TRANS/WP.29/GRSG/2003/21/Add.1
29 January 2004

**PROPOSAL FOR SUPPLEMENT 1 TO THE DRAFT 02 SERIES OF AMENDMENTS TO
REGULATION No. 107**

(M2 and M3 vehicles)

Transmitted by the expert from the International Organization
of Motor Vehicle Manufacturers (OICA)

"Figure 11b
SPACE FOR FEET OF SEATED PASSENGERS BEHIND A SEAT AND/OR A SEAT
FACING THE GANGWAY
(see annex 3, paragraph 7.7.8.5.2.)

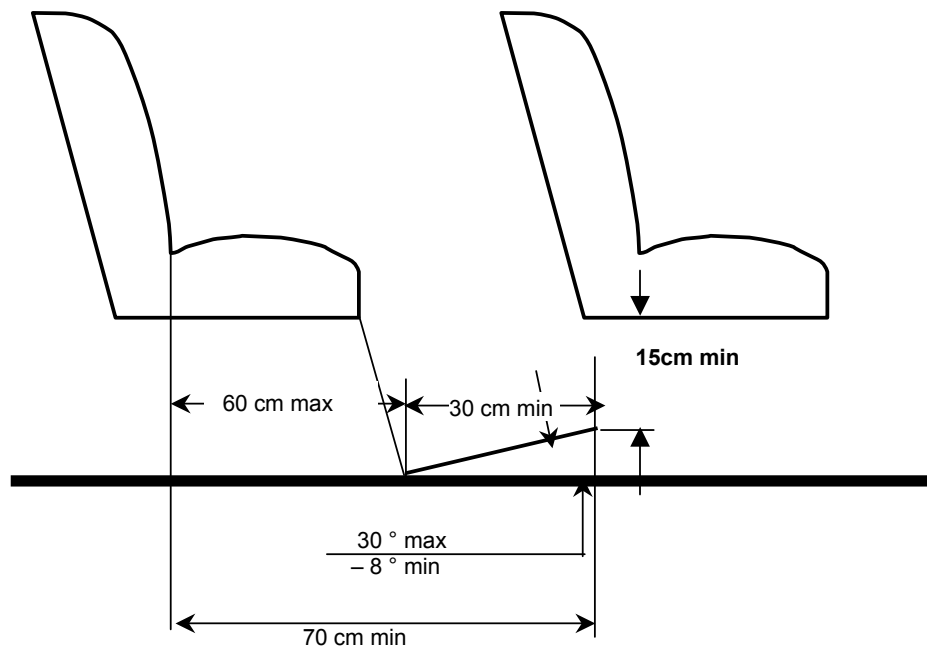
"7.7.8.5.2. For a seat behind a seat and/or a seat facing the gangway, a minimum clear foot space of at least 300 mm depth and a width according to paragraph 7.7.8.1.1., shall be provided as shown in annex 4, figure 11b. The local presence in this space of seat legs and of intrusions as provided by paragraph 7.7.8.6 shall be permitted provided that adequate space remains for the passengers' feet. This foot space may partly be situated in and/or above the gangway but shall not create any obstruction when measuring the minimum gangway-width in accordance with paragraph 7.7.5. In the case of seats alongside the driver's seat in vehicles with up to 22 passengers, intrusion of the seat belts and seat belt anchorages shall be allowed. "

Insert a new figure 11b, to read: **

(The diagram shown in Part A of this document is believed to better reflect the intention of GRSG than that contained in the minutes. GRSG should consider both versions and decide which one to use.)

"Figure 27
ACCESS TO DRIVER'S DOOR
(See annex 3, paragraph 7.6.1.7.2.)

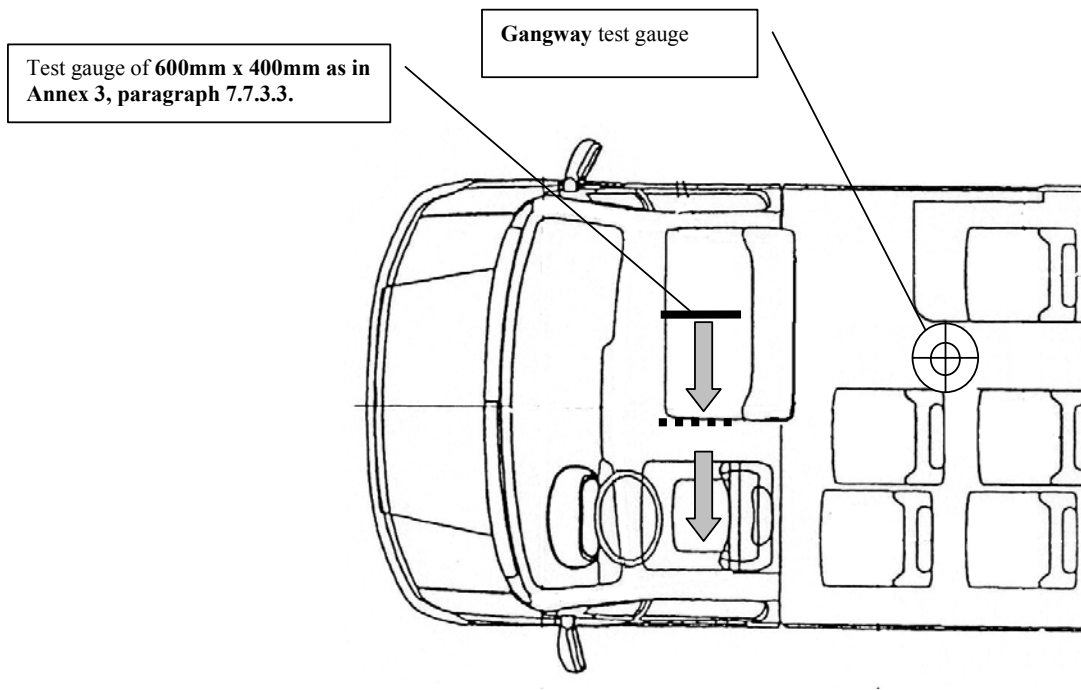
The driver's door shall be accepted as the emergency door for the occupants of those seats, provided that it is possible to move a test gauge from the occupants' seats to the exterior of the vehicle through the driver's door (see annex 4, figure 27).

Insert new figures 27 and 28, to read: ***

Figure 28
ACCESS TO DRIVER'S DOOR
(See Annex 3, paragraph 5.7.2.4.2.)

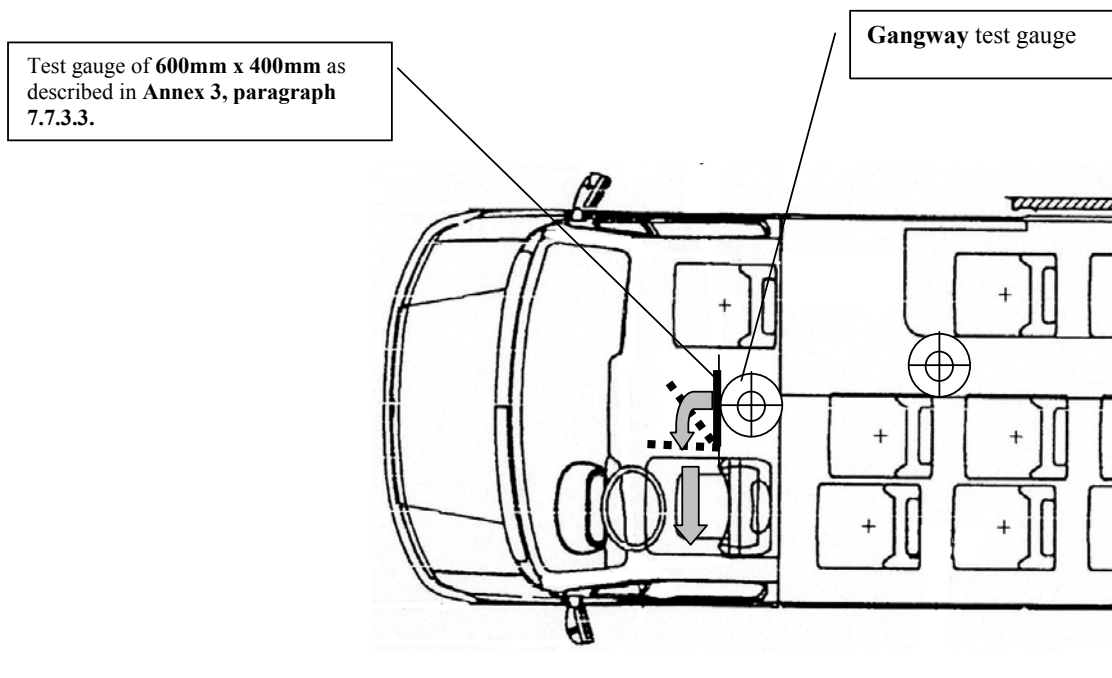
7.6.1.9.3. the space reserved for the driver's seat shall communicate with the main passengers' compartment through an appropriate passage; such requirement shall be deemed to be fulfilled if the test gauge described in paragraph 7.7.5.1. can move unobstructed from the gangway, until the front end of the gauge reaches the vertical plane tangential to the foremost point of the driver's seat back (this seat being situated in its rearmost longitudinal position) and, from this plane, the panel described in paragraph 7.6.1.7.2. could be moved to the emergency door in the direction established by such paragraph (see annex 4, figure 28) with seat and steering wheel adjustment in their mid position."

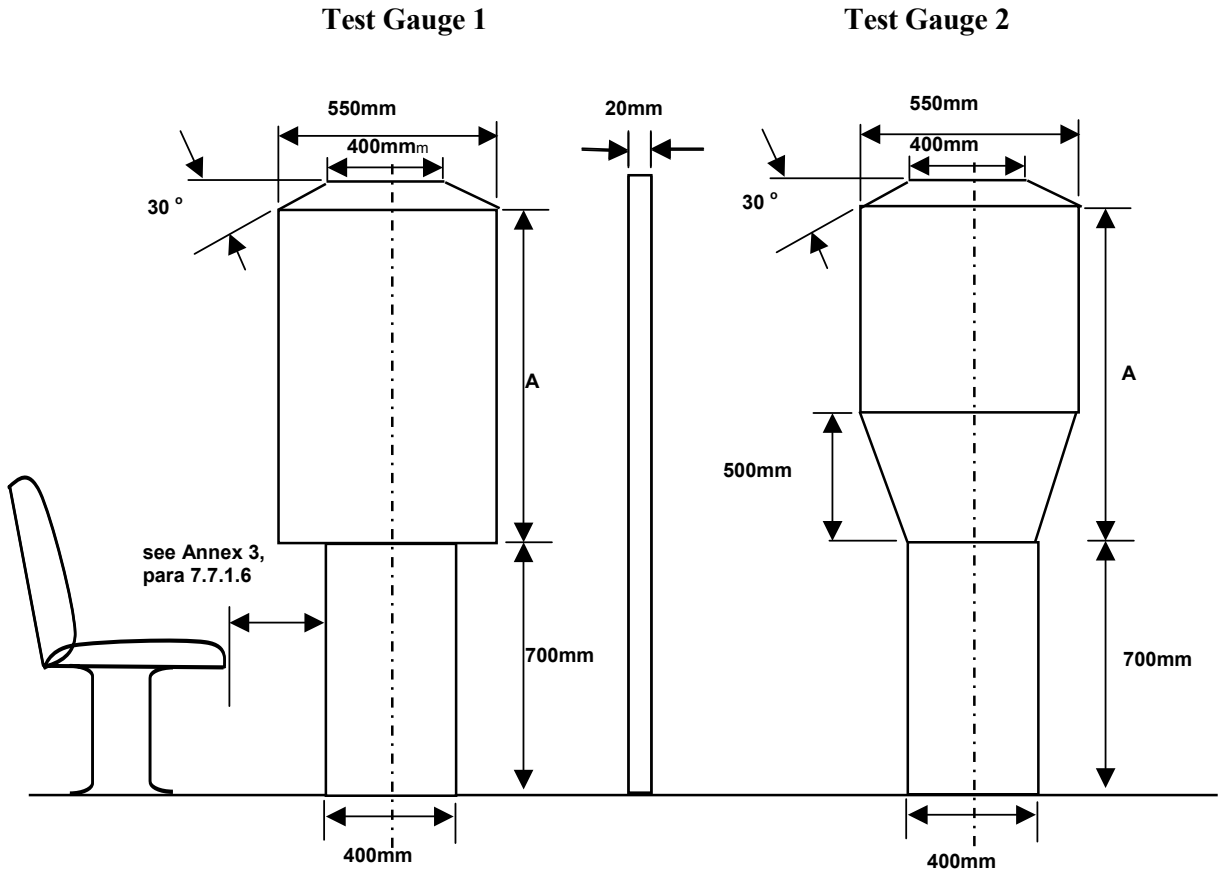
Annex 4, figure 1, amend to read:

"Figure 1
ACCESS TO SERVICE DOORS

Re. annex 4, figure 1

Figure redrawn to correctly reflect the text.

Vehicle Class	Height of the upper panel (mm) (Dimension "A", figure 1)		Total height
	Test gauge 1	Test gauge 2	
Class A	950 (*)	950	1650
Class B	700 (*)	950	1400
Class I	1100	1100	1800
Class II	950	1100	1650
Class III	850	1100	1550

(*) For vehicles having a capacity not exceeding 22 passengers, the lower panel may be displaced relative to the upper panel provided that it is in the same direction."
